MEMORANDUM

SUBJECT: BZA #19635 – 1121 Morse Street, NE – Special Exception to permit the expansion of a single family home and conversion to three apartment units

I. RECOMMENDATION

Image looking east on the subject block showing the consistent character of the houses. This image was created from photos taken prior to construction of the two apartments adjacent to the subject site.

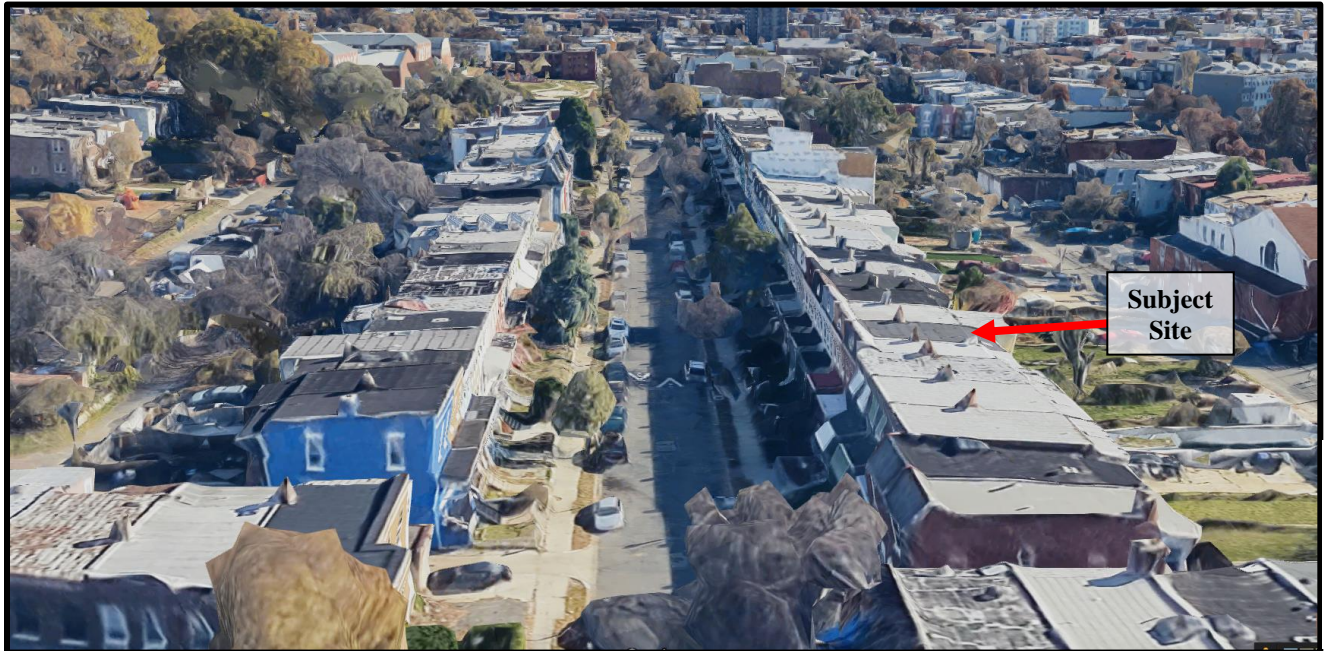
The proposed additions to the building would deviate from the long-established character of Morse Street, and the character of the subject block as seen from the alley. On Morse Street, most houses have two stories, and most have front porches. Almost all houses on the south side of the street, where the subject property sits, have an attic space situated behind a mansard roof with a dormer or dormers at the front of the building. This gives a nearly uniform appearance of “two-and-a-half” stories. At the rear, these deep lots enjoy consistently deep rear yards, and a somewhat consistent rear building wall.

While two adjacent properties have previously been expanded and converted to apartments, their appearance intrudes upon the overall look of the block. Their front façades are higher and more flat than others on the block, lacking the traditional front porch and mansard roof. The rear additions extend very far into the rear yard, impacting the pattern of houses on the alley side. The proposed conversion on the subject site would mimic these impacts from the already constructed apartments, further intruding on the prevailing character of the street.

Should the applicant wish to redesign the project, OP has recommended that the existing mansard roof and front porch be maintained, and that the third floor be set back from the existing façade. OP has also recommended that the applicant examine a smaller footprint for the rear addition.
